Comal County Environmental Health

OSSF Inspection Sheet

Permit#: **118958**

Address: **728 FLIGHTLINE DR**

site map
 Aerobic with Drip
 irrigation system
 Michael and Sheridan
 Buck Rvcbl trust
 Lot 9, block 7
 Kestral Air Park
 728 Flightline Drive
 Spring Branch, Texas 78070
 Comal County

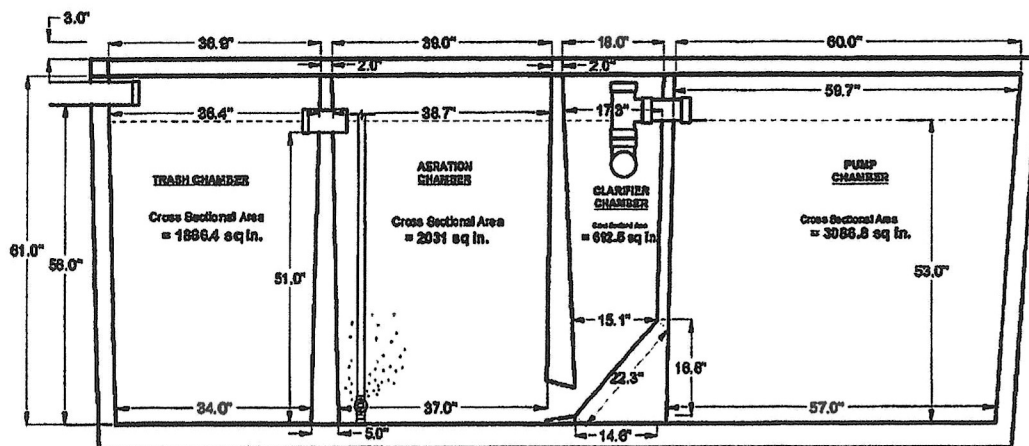
Show the 12ft. utility easement, and maintain necessary setbacks.

Thank you for your submission. We have reviewed the planning materials for the referenced permit application, and unfortunately, they are insufficient. To proceed with processing this permit, we require the following:

12' utility easement and 1 ft buffer for a total of 13' between drip tubing and property line
